Figure 1 - Current KNPP RPV Cooldown P-T Limit Curves Through 28 EFPY

Figure 2 - Proposed KNPP RPV Cooldown P-T Limit Curves Through 33 EFPY

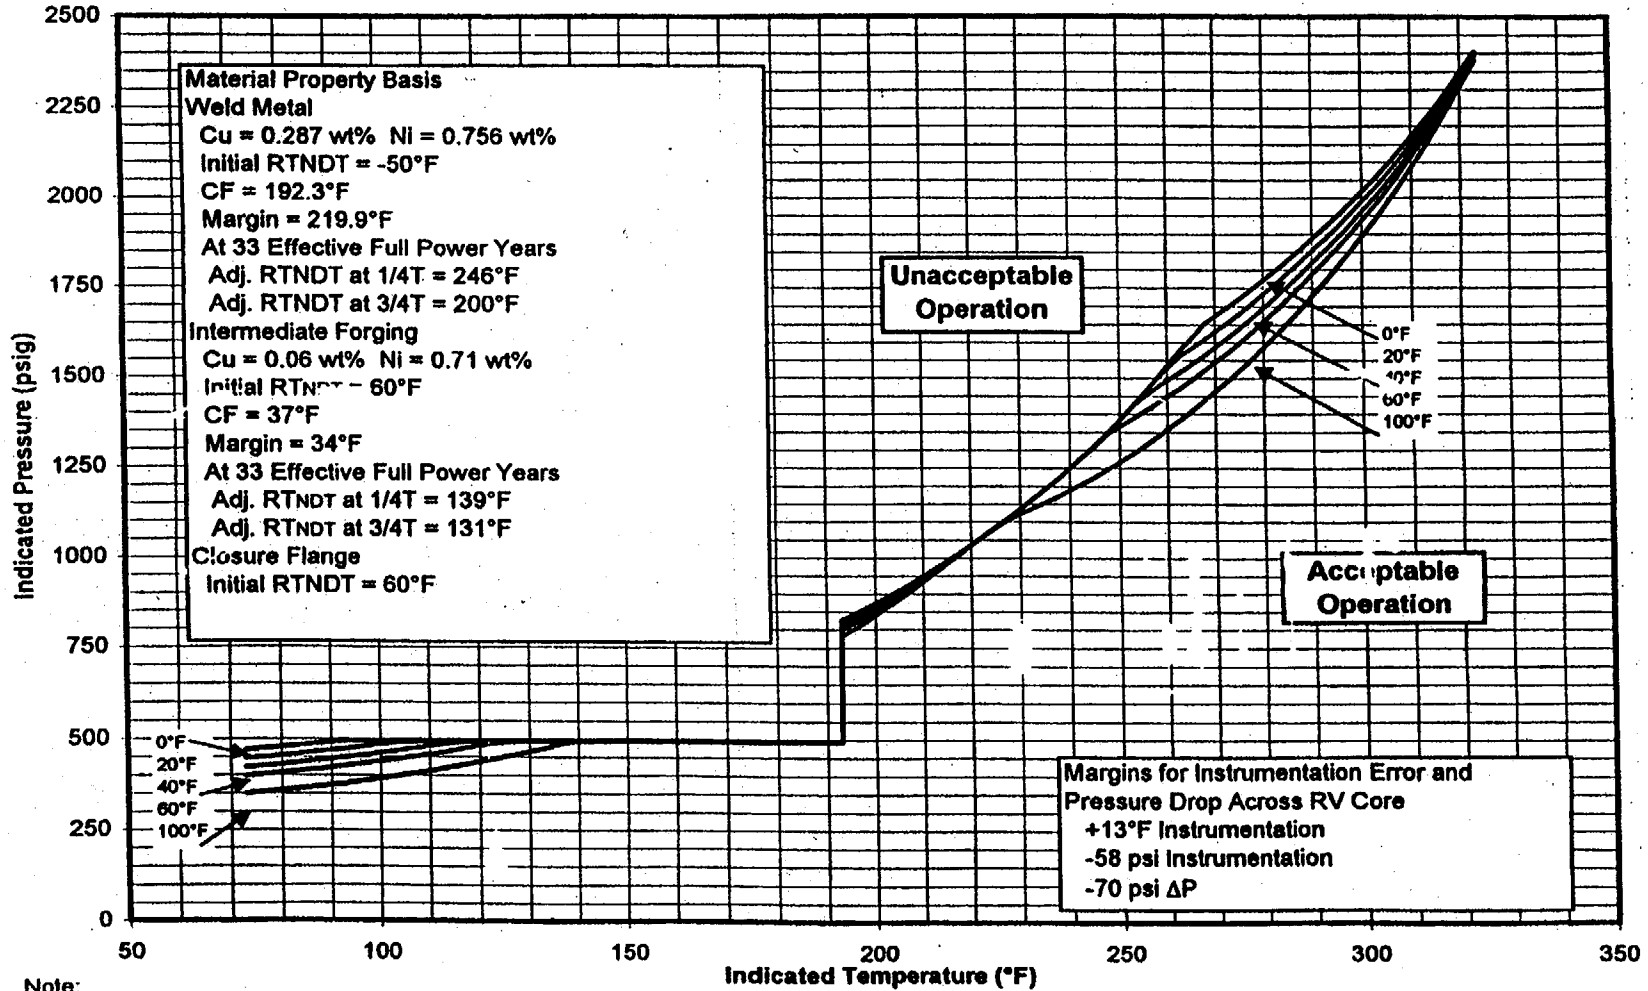
⁽¹⁾ Although the curves were developed for 33 EFPY, they are limited to 28 EFPY (corresponding to the end of cycle 28) by WPSC Letter NRC-99-017.
